SUBJECT: Campaign #92 – Am-Safe Seat Belt Buckle

INSTRUCTIONS TO PERFORM CAMPAIGN #92

Replacement of Seat Belt Buckle Assembly on a Limited Number of Class A Motorhomes and Rialta Motorhomes

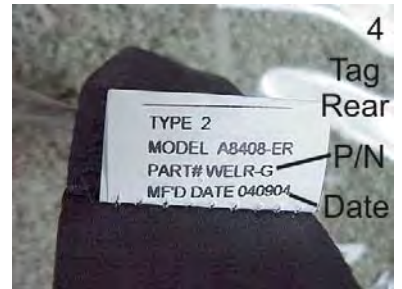
The Am-Safe seat belt buckle involved in this campaign is an end-release style buckle identified by a red release button with the word “PRESS” embossed onto it as shown in photos 1 and 2.

Buckles with a center button release containing an oval globe logo are not included in this campaign.

This campaign involves replacing only the buckle-end of the belt— not the tongue-end.
